STAFF REPORT
(Preliminary Plat)

CASE NUMBER: SUB 2003-65 -- RIVENDALE ADDITION

STAFF REPORT

CASE NUMBER: SUB 2003-65 -- RIVENDALE ADDITION

Stormwater Sewer #5 Revision

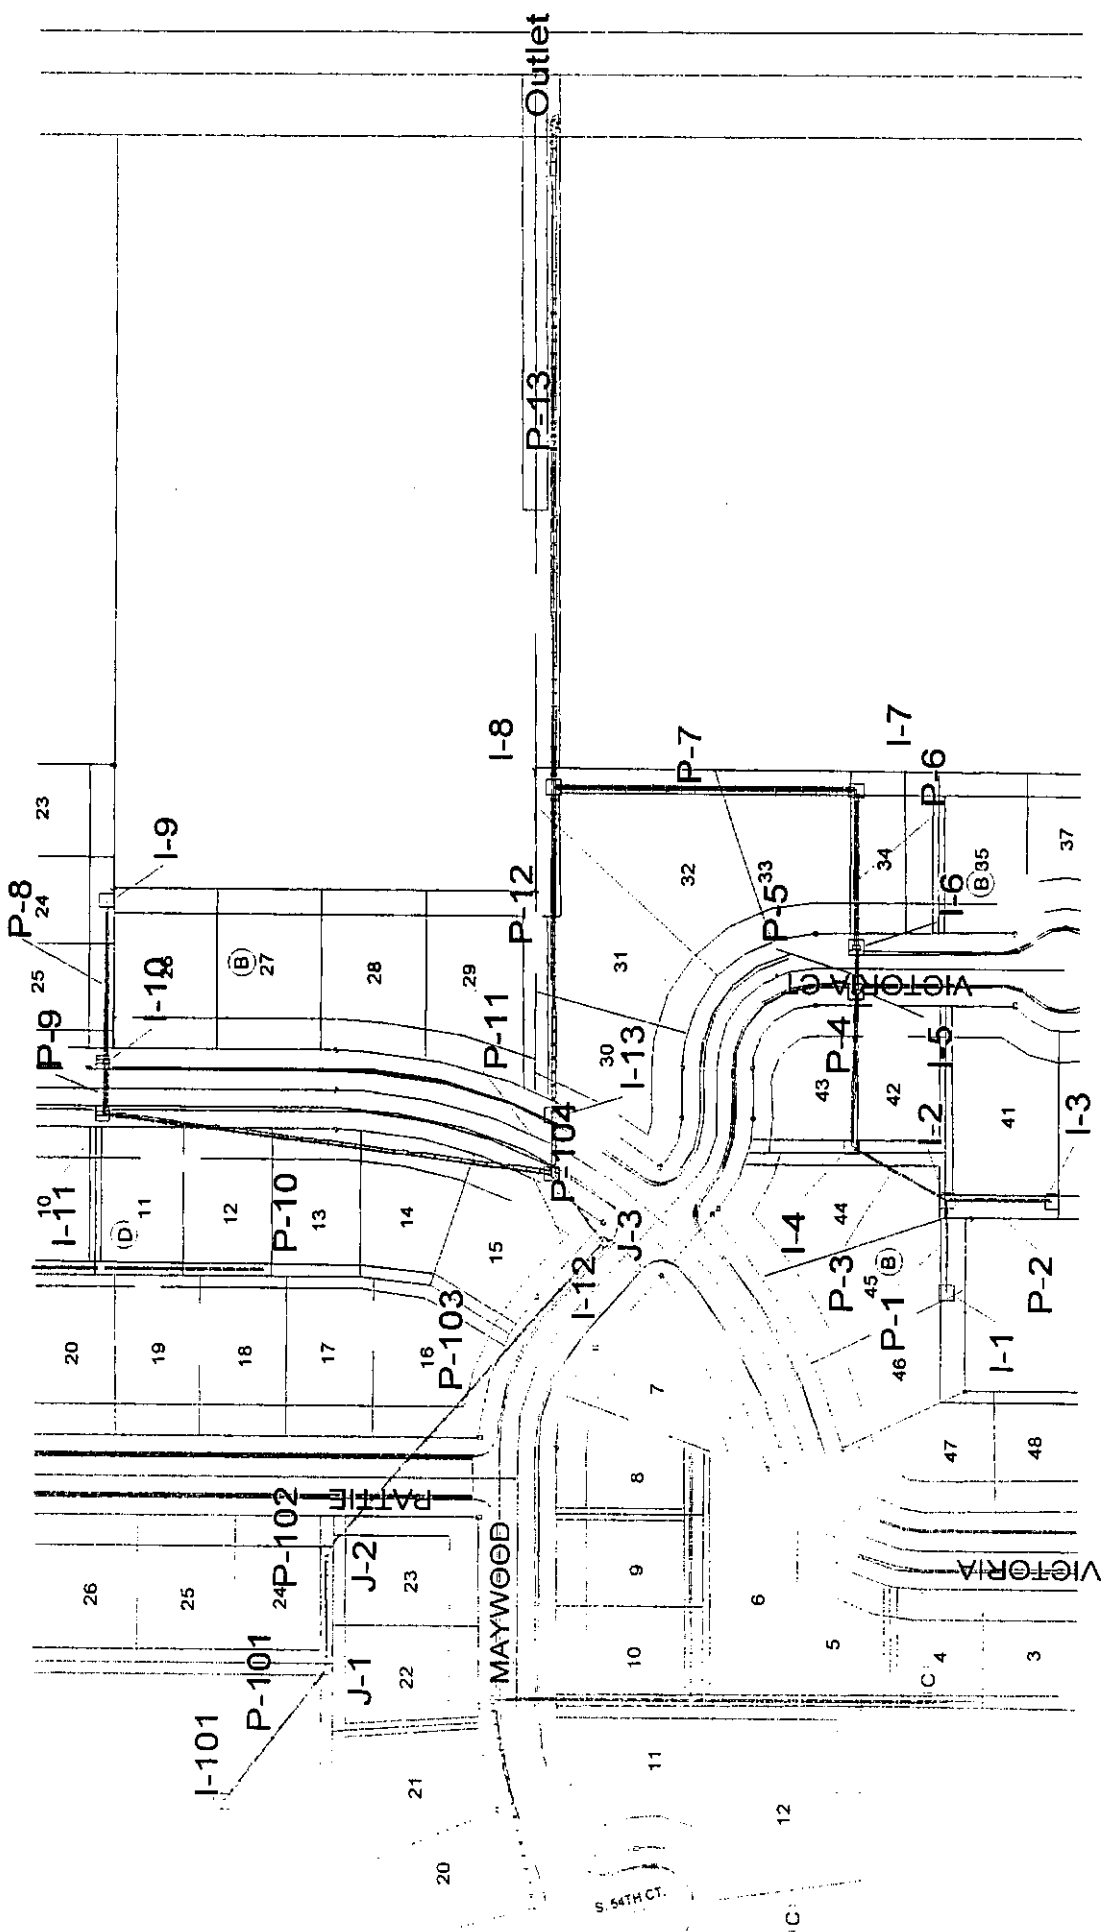
Stormwater Sewer #5 has been revised to incorporate a gravity outlet for the detention pond facility. Although the static water surface is controlled by groundwater at elevation 70 city datum, a 15 inch RCP at elevation 71.5 city datum, is now proposed as a secondary control for the facility.

The calculated volume of runoff collected by the pond remains as noted in the July 15, 2003 drainage plan, however the 100-yr water surface is being revised to provide additional protection to the structures in the event of a significant rainfall during the time when the pond is regaining capacity.

By neglecting the storage volume between the static level and the elevation of the gravity outlet, the 100-yr water surface will achieve an elevation of 75.6 city datum. Allowing for freeboard, the minimum lowest opening to the structures will be established at elevation 77.0 city datum.

The rainfall volume collected by the pond, as previously submitted, is 28.3 ac-ft (approximately 1,233,000 c.f.). The uniform flow capacity of a 15-inch RCP at a 0.38% slope is 4 cfs. Dividing the rainfall volume by the rate of discharge and converting, the 100-yr rainfall would be dissipated (i.e. reclamation of storage capacity) in under 86 hrs. (3.6 days).
